Access Compliance Report Public Rights-of-Way (RR Crossings)

Intersection ID: 7131	Main Street: N_TRYON_ST	Location: N/A
ADA ID: B30C3397D2C0	Overall Compliance: No	Severity Score: 0.0
Codes/Mitigation Info/Possible Solution		Field Measurements/Component Compliance

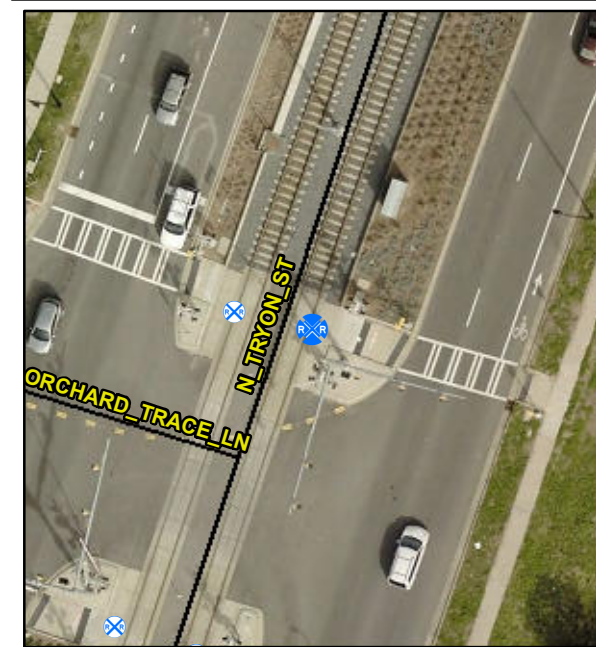
**Remove & Replace Walking Surface
Adjacent to Rail.**

R302.7.4

Compliance	Description	Data
Yes	DWS Provided?	Yes
Yes	DWS Contrast?	Yes
Yes	DWS Width (in)	Yes
Yes	DWS Length (in)	24.0
Yes	DWS Offset (in)	138.5
Yes	Pedestrian Gate?	Yes
N/A	DWS Outside Gate?	Yes
N/A	Rail Type?	LightRail
No	Flangeway Gap (in)	2.5
Yes	Sidewalk Width (in)	120.0
